Re: Soil Delineation Concentrations
Refined Metals Corporation
Beech Grove, Indiana
EPA I.D. No. IND000718130

Phase II RCRA Facility Investigation Report
Refined Metals Corporation
IND 000 718 130

RE: Response to EPA Comment Letter dated December 31, 2002
Refined Metals Facility
Beech Grove, IN
IND 000 718 130

RE: Phase II RCRA Facility Investigation Report
Response to Comments
IND 000 718 130

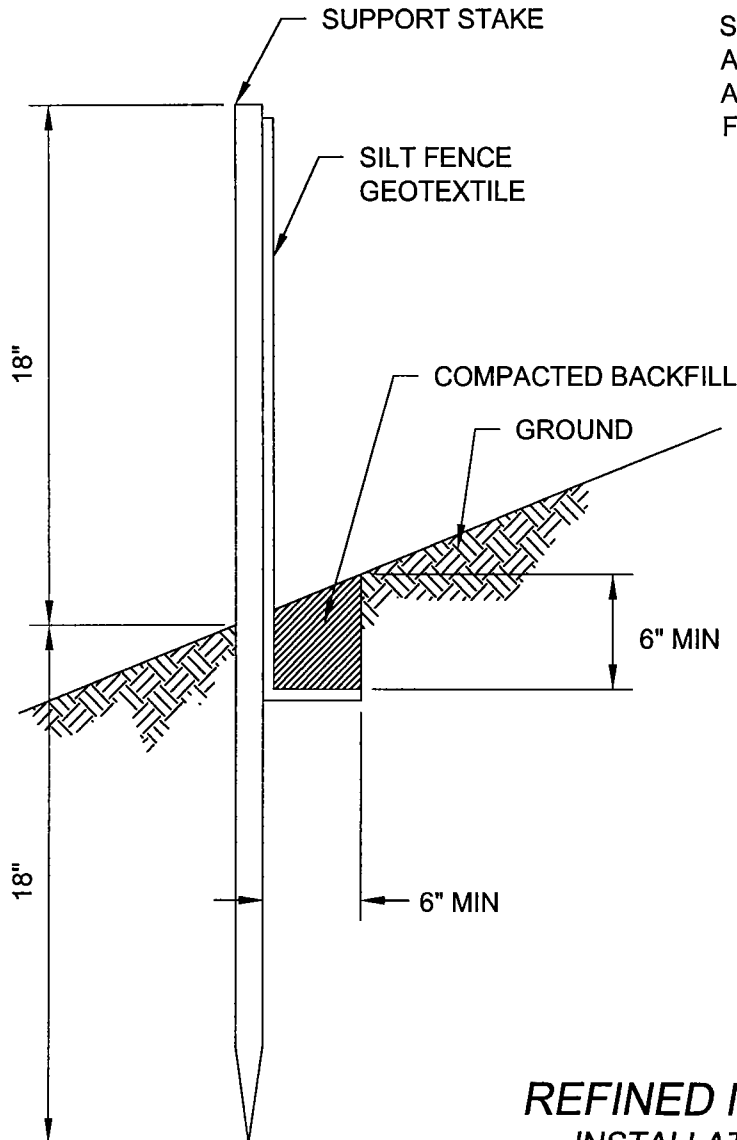
Silt fence will be placed at the locations shown in Figure 1. The silt fence will be installed as shown. The silt fence will be installed according to the specifications and to the dimensions shown on Figure 4. Silt fence will remain in-place until disturbed areas have been re-stabilized with vegetation that will be seeded by the Contractor following completion of check dam construction.
